Subject: Class 1 Permit Modification Notifications, Waste Isolation Pilot Plant Hazardous Waste Facility Permit Number: NM4890139088-TSDF

**Class 1 Permit Modification Notifications**

**Waste Isolation Pilot Plant  
Carlsbad, New Mexico**

**WIPP Permit Number - NM4890139088-TSDF**

**Figure D-4-NFB**  
**Fire-Water Distribution System with Building 416**

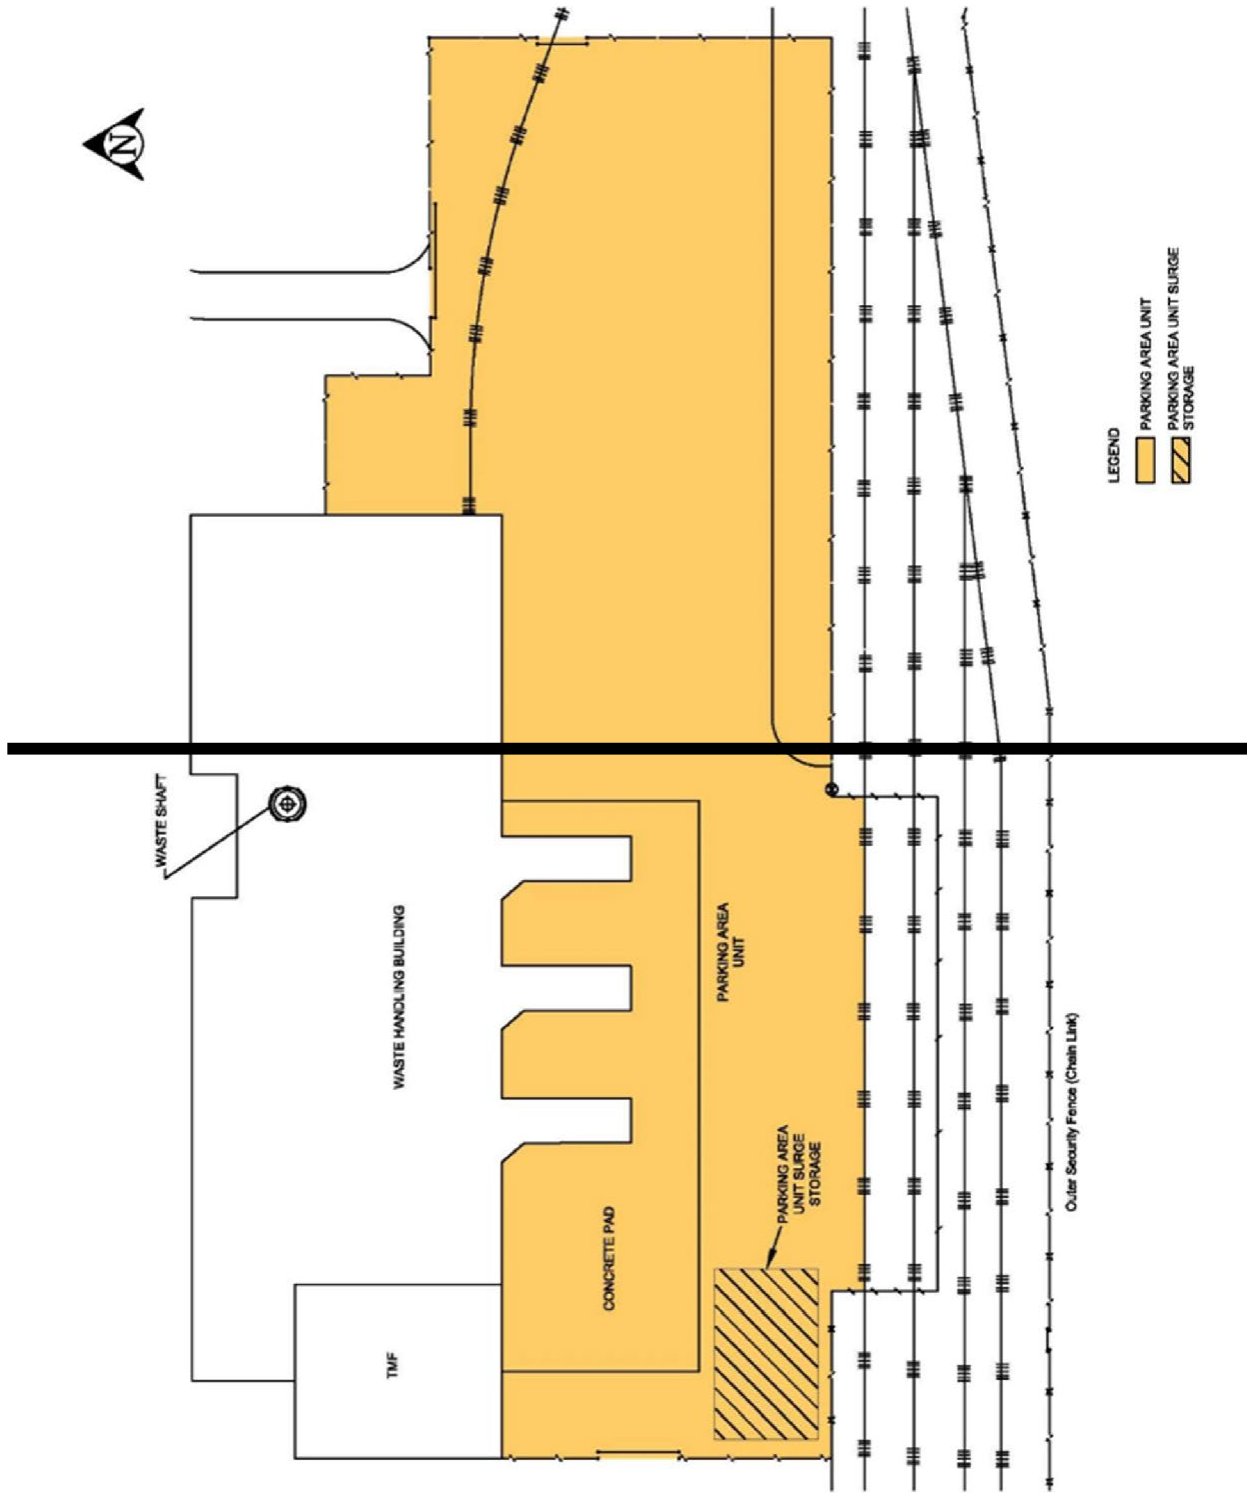
- Figure D-4-NFB, *Fire-Water Distribution System with Building 416*
    - Updated figure with the new fire water pump house (Building 490) and storage tanks (Tanks 491E and 491W) located in the northeast corner of the PPA, removed the rail tracks, moved the northeast fence line. The southeast fence line was not updated since the figure shows the future layout of the facility, and the southeast fence line change is temporary. Made other updates to the buildings and structures to ensure consistency with other figures in the Permit that show the surface structures and to ensure consistency with the current layout of the facility.

**Figure M-2**  
**Parking Area Unit – TRU Mixed Waste Container Storage and Surge Areas**

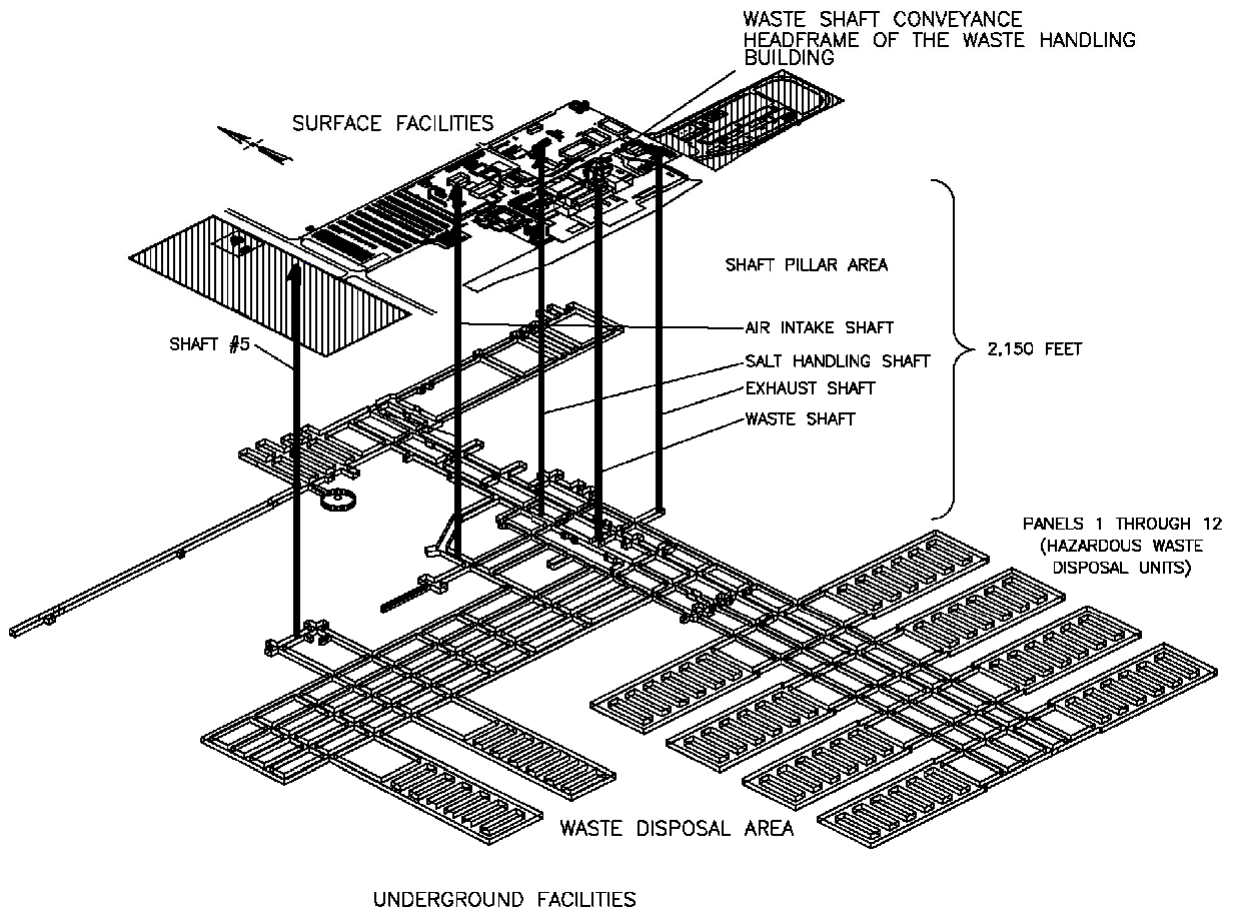
- Updated figure to remove the rail tracks, update southeast fence line, and extended shading on the figure to the fence line.
- Figure M-44, *Spatial View of the Miscellaneous Unit and Waste Handling Facility*

Permit Part 3, Section 3.1.2, has been updated to remove the reference to rail tracks. Figures B3-3 and M-2 have been updated to remove the rail tracks and extend the shading to the southern fence line. These changes are needed since the rail tracks are not being used and have been removed. These changes ensure the text and figures are consistent with the text in Permit Attachment A, Section A-4, and Permit Attachment A1, Section A1-4, which describe the

**Figure M-44**  
**Spatial View of the Miscellaneous Unit and Waste Handling Facility**

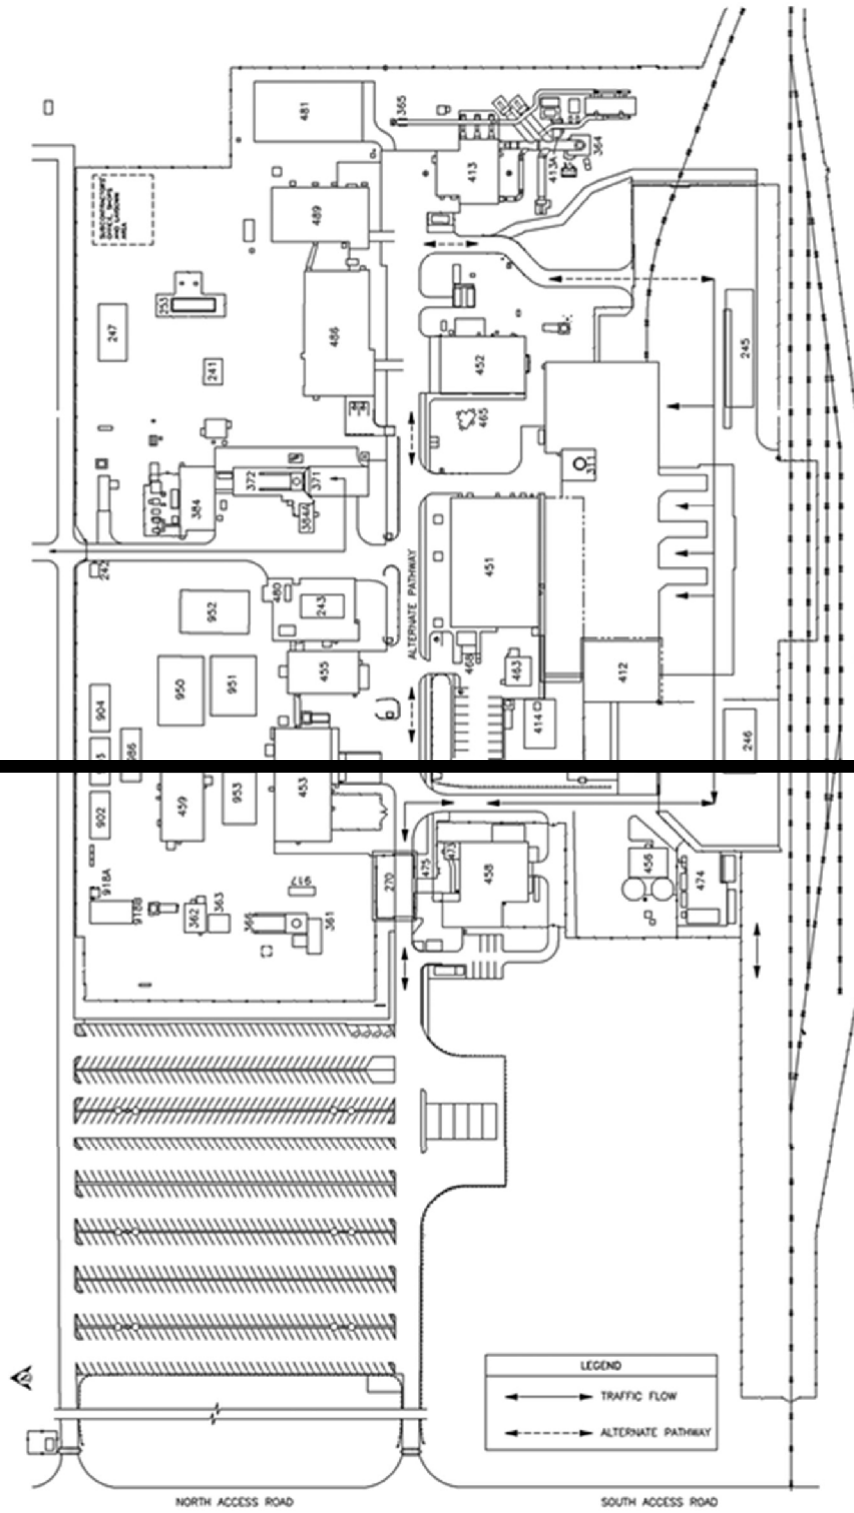
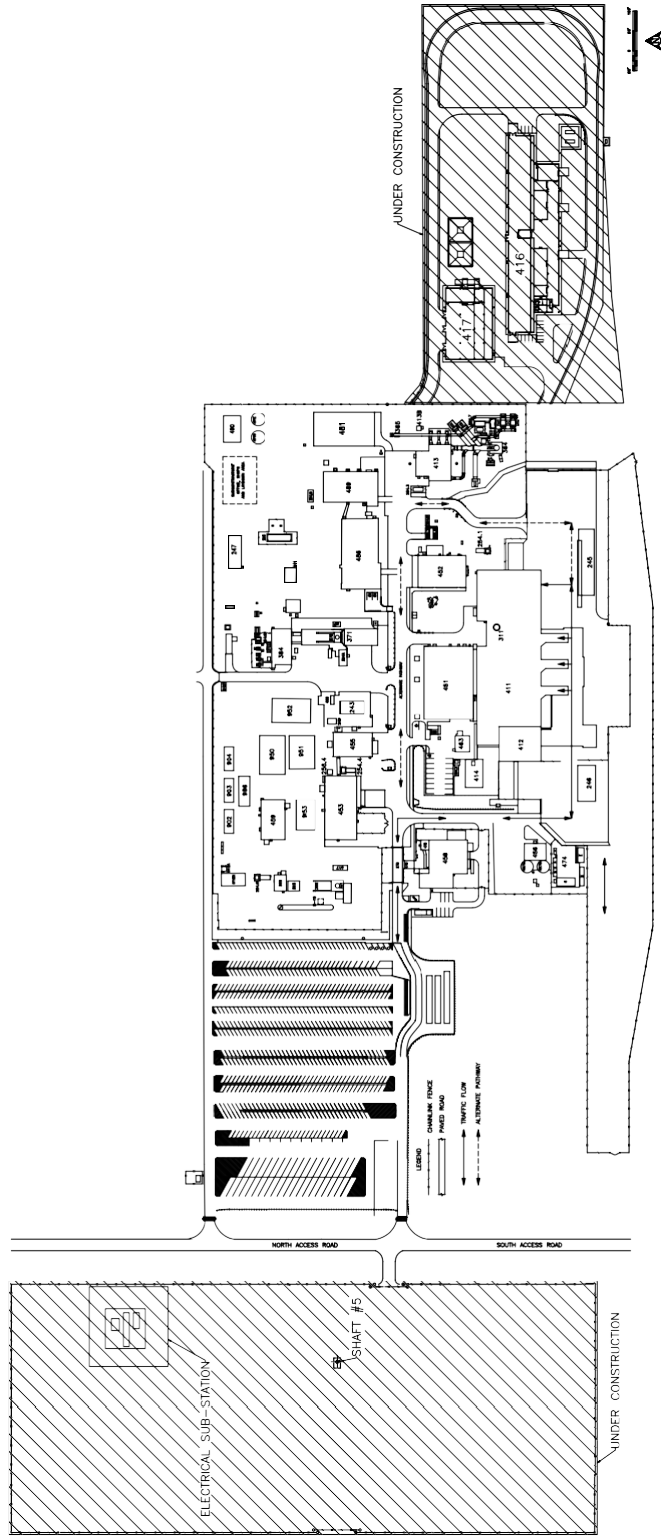
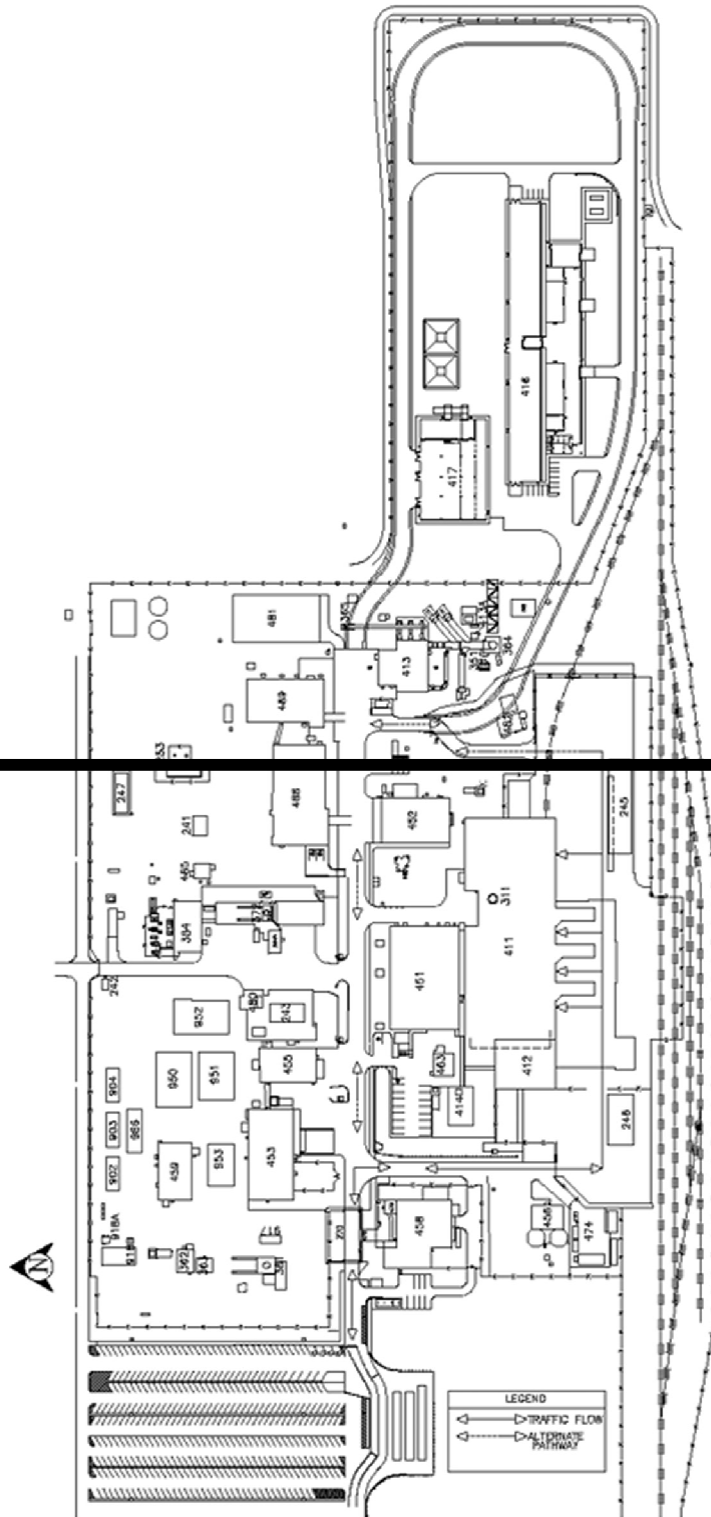
- Updated figure with the Shaft #5 and the SSCVS. Made other updates to the buildings and structures to ensure consistency with other figures in the Permit that show the surface structures and to ensure consistency with the current layout of the facility.

Permit Attachment B, Figure B3-1, Permit Attachment D, Figure D-2, and Permit Attachment M, Figure M-44, have been replaced with a figure that includes the Shaft #5 and SSCVS areas and updated other areas to ensure consistency with other figures that depict the surface and underground facilities and ensure consistency with the current layout of the facility.

**Figure M-58**  
**WIPP Traffic Flow Diagram**

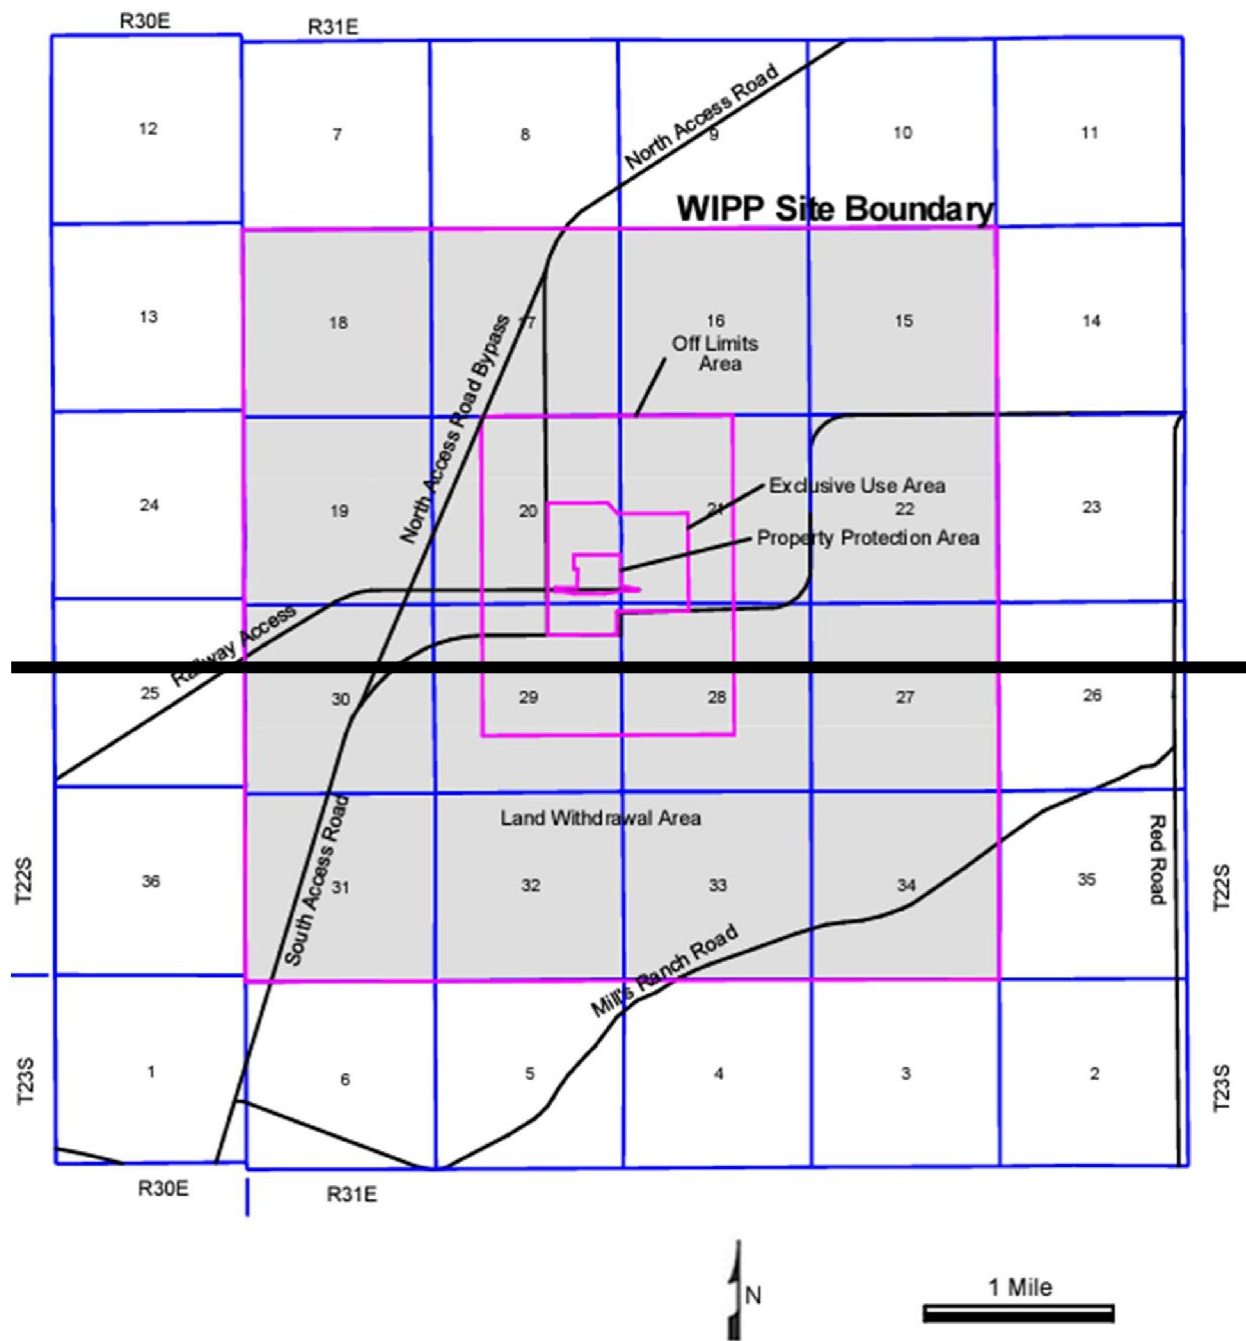
- Figure M-58, *WIPP Traffic Flow Diagram*
  - Updated figure with the new fire water pump house (Building 490) and storage tanks (Tanks 491E and 491W), removed the rail tracks, moved the northeast and southeast fence lines, updated the parking lot layout. Portions of this figure have been updated to be consistent with Figure D-1 such as the depiction of the Interim Ventilation System at the east of the facility, added building labels for Building 254.3 and the water tanks and hazardous material storage area, updated lines around Building 311 and within the Parking Area Container Storage Unit, and moved the north direction arrow. Information from Figure M-59 was moved to this figure and the Shaft #5 area was added. Shading has been added over areas that are currently under construction (i.e., Shaft #5 and the SSCVS).

Permit Attachment D, Figure D-1, has been replaced with a figure that includes the Shaft #5 and SSCVS areas and Figure D-1-NFB has been removed since this information is now shown in Figure D-1. Permit Attachment M, Figure M-58, has been replaced with a figure that includes the Shaft #5 and SSCVS areas and Permit Attachment M, Figure M-59, has been removed since this information is now shown in Figure M-58. In addition, Permit Attachment D, Figures D-1, D-4, D-4-NFB, and Permit Attachment M, Figure M-58, have been updated to ensure consistency with the current layout of the WIPP facility and consistency between figures. For example, the new fire water pump house (Building 490) and tanks (Tanks 491E and 491W) have been added, the rail tracks have been removed, the parking lot configuration has been updated, and the southeast fence line has been moved to reflect the current layout at the facility. Other updates to these figures have been made to ensure they are consistent with each other (e.g., labeling, line placement, marker placement, etc.). These changes are needed to update the Permit with the current layout of the facility and to streamline figures.
